STAFF REPORT
(One-Step Final Plat)

CASE NUMBER: SUB 2008-90 – HILLER ADDITION

Hiller Addition
 Site Plan
 Wichita, Kansas

VICINITY MAP

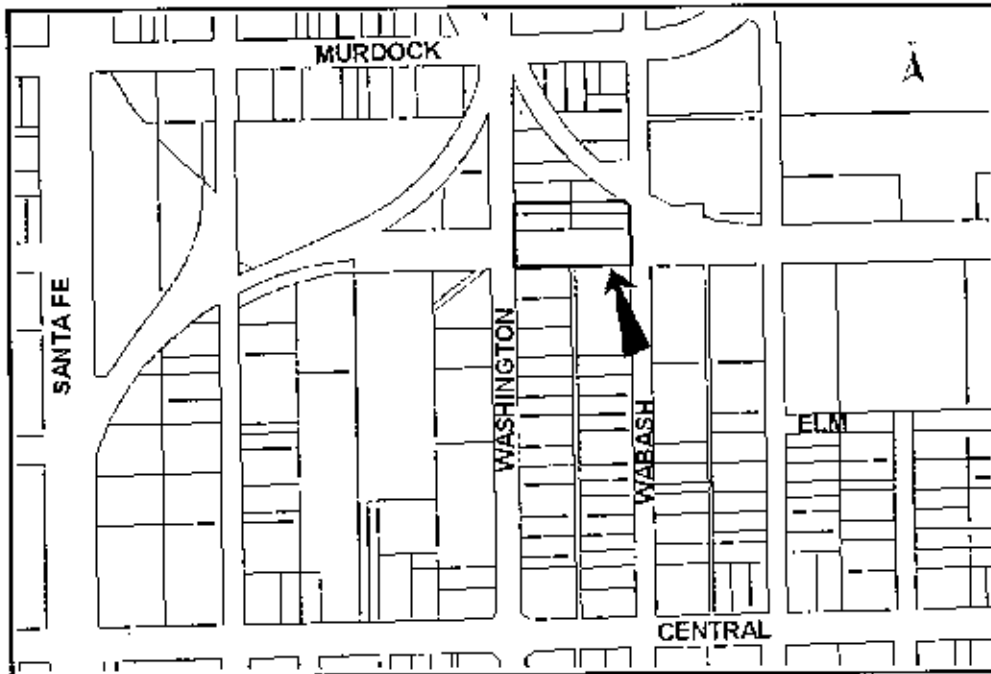
- E. County Surveying notes that the label at Central and Washington needs to be changed to the southwest corner.
 - F. The applicant shall guarantee the closure of any driveway openings located in areas of complete access control or that exceed the number of allowed openings. A Driveway Closure Certificate in lieu of a guarantee may be provided.
